Project	IEEE 802.16 Broadband Wireless Access Working Group < http://ieee802.org/16 >	
Title	Improved Data and Pilot Allocation for Cellular OFDMA Systems with Multiple Antennas	
Date Submitted	2004-06-25	
Source(s)	<p>Wonil Roh, JeongTae Oh, Chan-Byoung Chae, Kyunbyoung Ko, Hongsil Jeong, Sung-Ryul Yun, Seungjoo Maeng, Panyuh Joo, Jaeho Jeon</p> <p>Samsung Electronics Co., Ltd.</p> <p>Wen Tong, Peiyong Zhu, Jianglei Ma, Ming Jia</p> <p>Nortel Networks</p>	<p>wonil.roh@samsung.com</p> <p>Voice: +82-31-279-3868</p> <p>wentong@nortelnetworks.com</p> <p>Voice: +1-613-763-1315</p>
Re:	Contribution supporting TGe WG ballot #14b	
Abstract	Improved Data and Pilot Allocation for Cellular OFDMA Systems with Multiple Antennas	
Purpose	Adoption of proposed changes into P802.16e	
Notice	This document has been prepared to assist IEEE 802.16. It is offered as a basis for discussion and is not binding on the contributing individual(s) or organization(s). The material in this document is subject to change in form and content after further study. The contributor(s) reserve(s) the right to add, amend or withdraw material contained herein.

Improved Data and Pilot Allocation for Cellular OFDMA System

Figure aaa - Illustration of STC for optional zones in DL

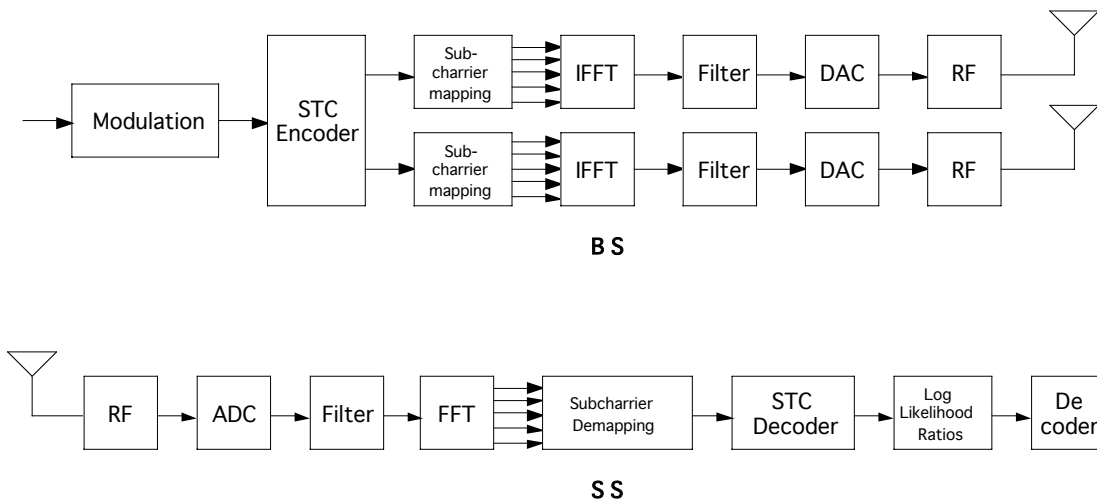
[Two optional zones for the downlink, the optional FUSC and the optional AMC zones, are described in 8.4.6.1.2.3 and 8.4.6.3 \[2\], respectively. STC may be used to improve system performance for these zones and an example of transmit diversity \(TD\) with 2 tx and 1 rx is shown in Figure aaa.](#)

Figure bbb - Pilot allocation for 2-antenna BS for the optional FUSC and the optional AMC zones

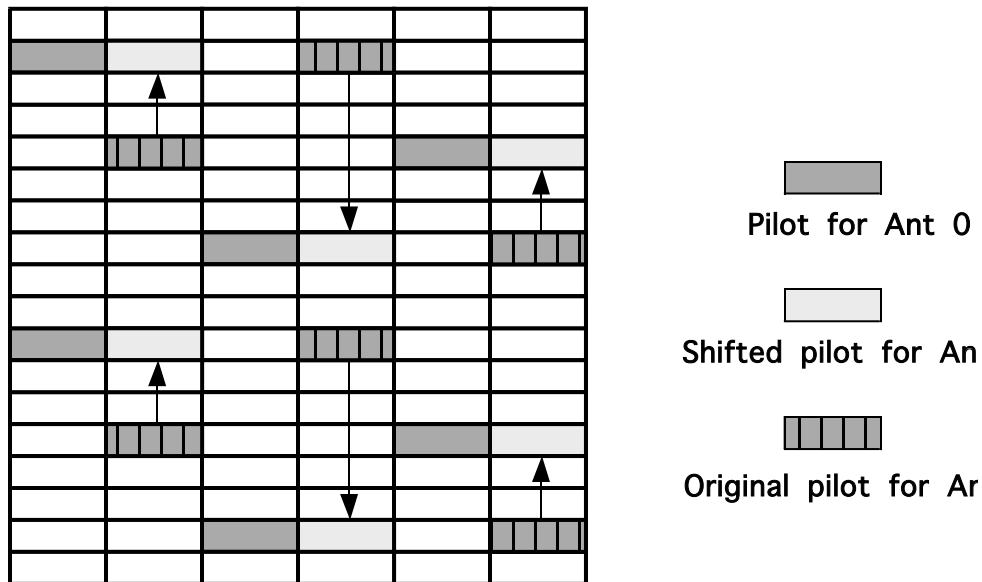
For 2-antenna BS, all pilots in the even symbols shall be allocated for antenna 0 whereas all pilots in the odd symbols shall be allocated for antenna 1. The positions of pilots in the odd symbols are further switched with those of data subcarriers whose locations coincide with pilots in the previous symbol. This is shown in Figure bbb.

Figure ccc - Pilot allocation for 4-antenna BS for the optional FUSC and the optional AMC zones

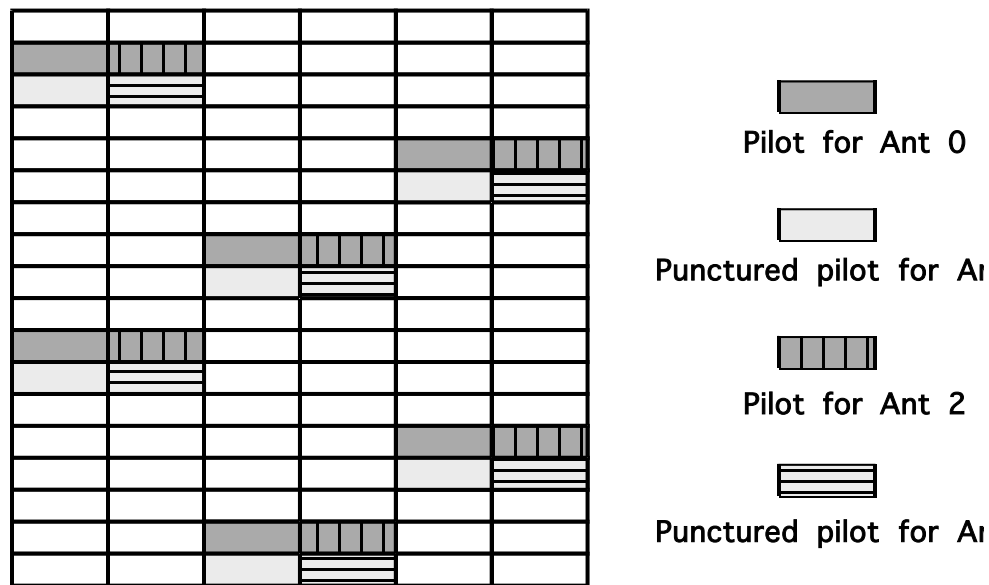
For 4-antenna BS, pilot pattern shall first be changed as in the 2-antenna BS case, and then the neighboring two subcarriers shall be further punctured for antenna 2 and 3 as is shown in Figure ccc.

[Figure ddd - Uplink pilot allocation for 2-antenna BS for the optional PUSC zones](#)

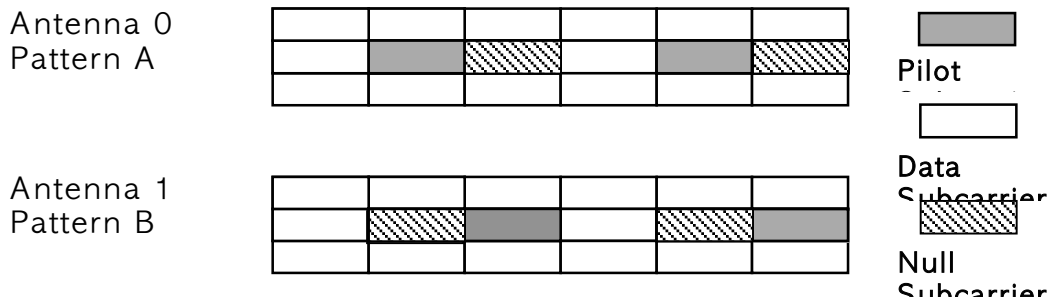
For 2-antenna SS and the optional PUSC, pilots for each antenna shall be allocated as shown in Figure ddd.

[In the uplink optional PUSC zone with transmit diversity \(TD\) mode, the data subchannels shall be allocated for mini subchannel \(type 01\) as shown in Figure ddd. For the optional AMC zone with TD mode, the data subchannels shall be either 1x6 \(1 bin in 6 symbols\) or 3x2 \(3 bins in 2 symbols\) bin combination.](#)

[Figure eee - Uplink pilot allocation for 2-antenna BS for the optional AMC zones](#)

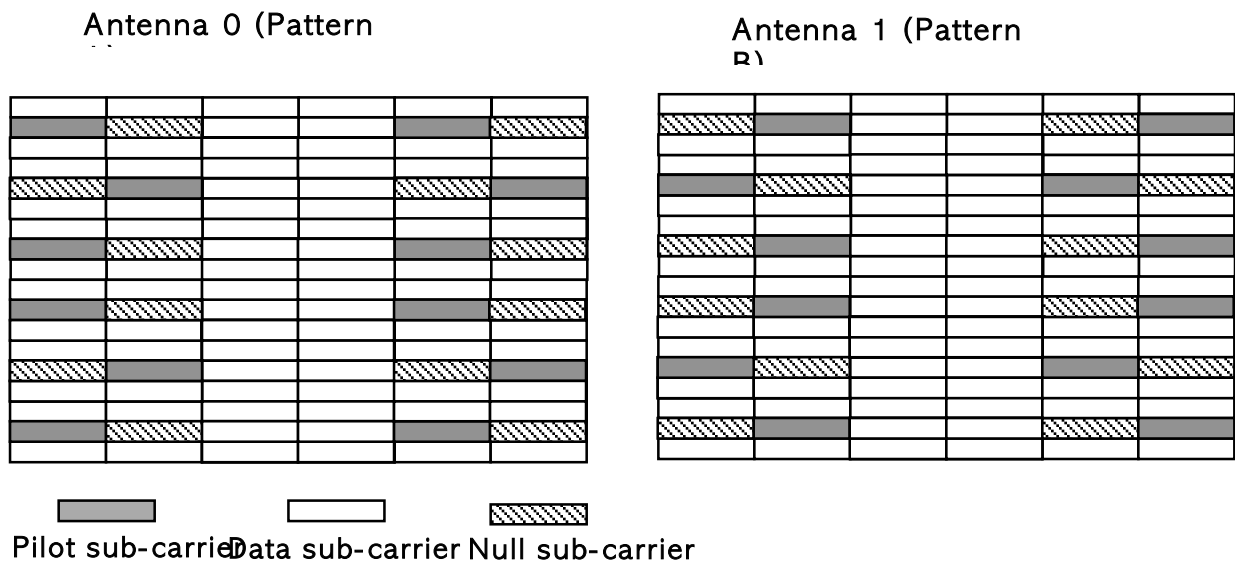
[For 2-antenna BS and the optional AMC, all pilots in the 1st, 2nd, 5th and 6th symbols shall be allocated for antenna 0, 1. This is shown in Figure eee.](#)
